PRODUCT / PROCESS CHANGE NOTIFICATION

1.1 Company	 STMicroelectronics International N.V
1.2 PCN No.	EMBEDDED PROCESSING/26/16070
1.3 Title of PCN	AMKOR ATJ (Japan) additional source for STM32H562x, STM32H563x and STM32H573x products in LQFP14x14 100L and LQFP20x20 144L packages.
1.4 Product Category	STM32H562x, STM32H563x and STM32H573x.
1.5 Issue date	2026-06-16

**PRODUCT/PROCESS
CHANGE NOTIFICATION
PCN16070
– Additional information**

Amkor ATJ (Japan) additional source for STM32H562x, STM32H563x and STM32H573x products in LQFP14x14 100L and LQFP20x20 144L packages.

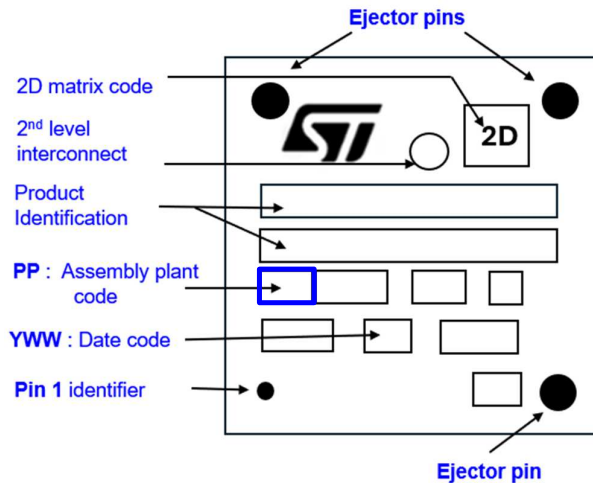
⁽¹⁾ Lead color and surface finishing may slightly vary depending on lead finishing.

⁽²⁾ Package darkness or chromaticity may change depending on molding compound.

Pin1 identifier may change in terms of size and positioning however remaining near pin1's edge.
Marking position and size may be different upon assembly site, without any loss of information.
